Joint Meeting of Experts on the Regulations annexed to the European Agreement concerning the International Carriage of Dangerous Goods by Inland Waterways (ADN) (ADN Safety Committee)

Report of the tenth Meeting of the Informal Working Group on Explosion Protection on Tank Vessels

Proposals to implement the new zone concept in ADN

No service spaces within cofferdam

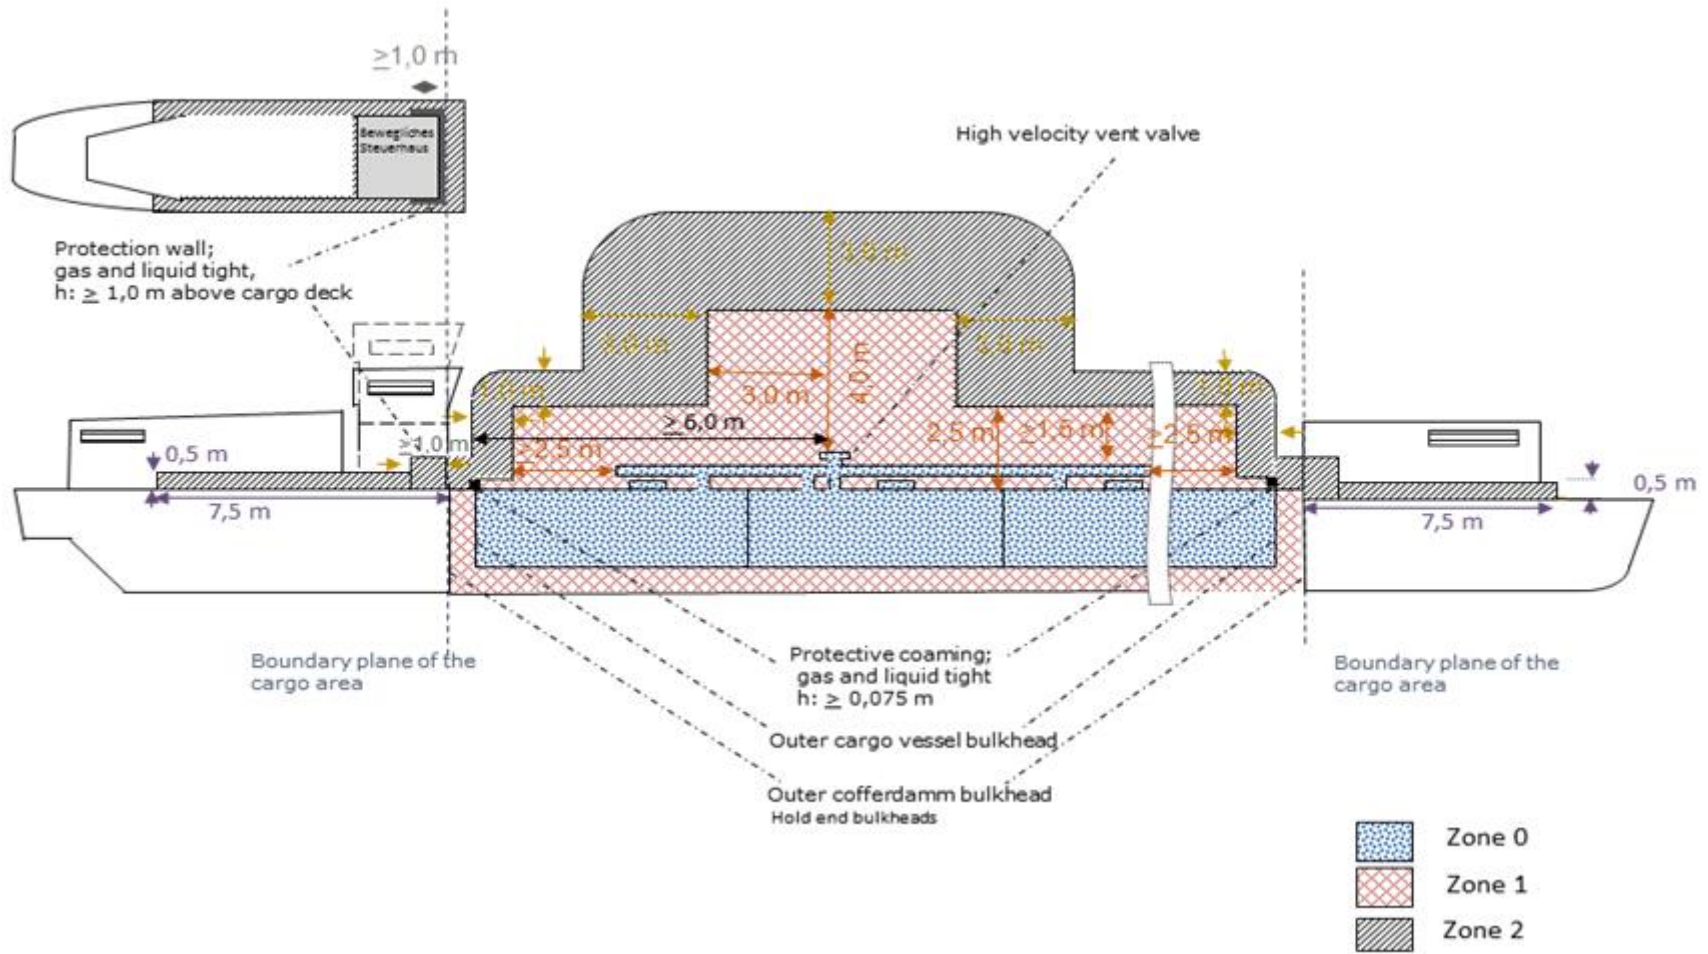
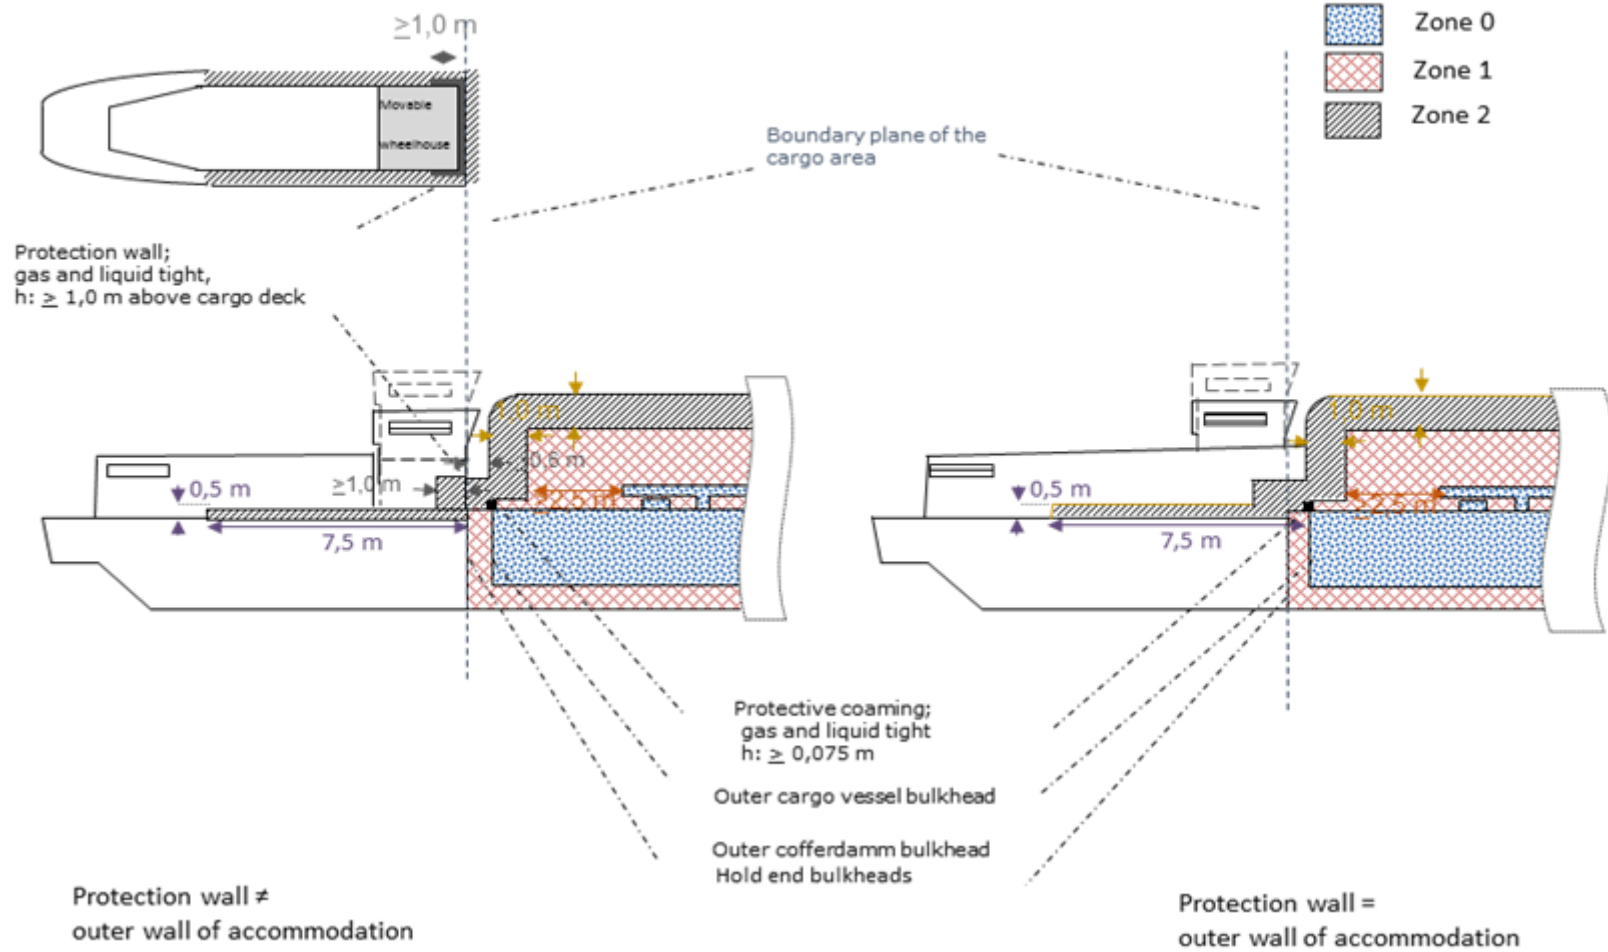
en, fr, de, ru	Paragraphs	Reason / Explanation
Zoneneinteilung Классификация зон	<p>contains substances for which explosion protection is required in column (17) of Table C of 3.2.3.2 (see drawing)</p> <p>Zone 0: comprises:</p> <ul style="list-style-type: none"> -  <u>all cargo tanks, tank-containers or portable tanks, pipings containing cargoes or cargo vapours including their equipment as well as pumps and compressors.</u> <p>Zone 1: comprises:</p> <ul style="list-style-type: none"> -  <u>compartments within the part of the cargo area below deck being not part of zone 0.</u> - <u>Compartments on deck within the cargo area.</u> - <u>The deck from one side of the vessel to the other within the cargo area up to the cofferdam bulkheads.</u> <p><u>Up to a distance of at least 1.6 m to the “boundary plane of the cargo area” the height above deck is 2.5 m, however at least 1.5 m above the highest piping carrying cargoes or cargo vapours. Adjacent (fore and aft) till the outermost cargo tank shots, the height is 0,25 m above deck. If there is a pump room installed inside the cofferdam the adjacent height (fore and aft) is 1.0 m above deck (see drawing).</u></p> <p><u>Adjacent (fore and aft) till the outer cargo tank bulkhead the height is 0.25 m.</u></p> <p><u>In case there are service spaces within the cofferdam or the vessel is build having hold end bulkheads the adjacent height (fore and aft) till the boundary plane of the cargo area is 1.0 m</u></p> <p><u>Whereas every opening in zone 0 except the high velocity vent valve has to be surrounded cylindrically by at least 2.5 m zone 1</u></p> <ul style="list-style-type: none"> - <u>An area surrounding cylindrically the high velocity vent valve/safety valve of cargo tanks of type G vessels with a radius of 3.0 m up to a height of 4.0 m above the opening of the high velocity vent valve/safety valve of cargo tanks of type G.</u> - <u>A spherical segment surrounding the ventilation openings of the service spaces located within the cargo area which are actively ventilated, comprising a radius of 1.0 m centred over the opening.</u> <p>Zone 2: comprises:</p> <ul style="list-style-type: none"> -  <u>An area on deck of 1.0 m in height and length following zone 1.</u> - <u>On the fore deck and the aft deck an area of the entire width of the vessel adjacent to boundary plane of the cargo area, with a complete length of 7.5 m. Between the lateral side of the vessel and the protection wall this area equals the length and height of the dimensions of the lateral side of the protection wall. Apart from that, the height is 0.5 m.</u> <p><u>This part is not part of zone 2 in case the protection wall extends from one side of the vessel to the other and there are no openings.</u></p>

<i>en, fr, de, ru</i>	<i>Paragraphs</i>	<i>Reason / Explanation</i>
	<ul style="list-style-type: none"> - <u>An area following zone 1 around the high velocity vent valve/safety valve of pressure cargo tanks having an expansion of 3.0 m.</u> - <u>A spherical segment following zone 1 which surrounds the ventilation openings of the service spaces located within the cargo area which are actively ventilated, comprising a radius of 1.0m centred over the opening.</u> - <u>The interior of closed compartments extending into zone 2 and being constructed in such a way that the penetration of gases from zone 2 is avoided, will not be part of the explosion hazardous area.</u>
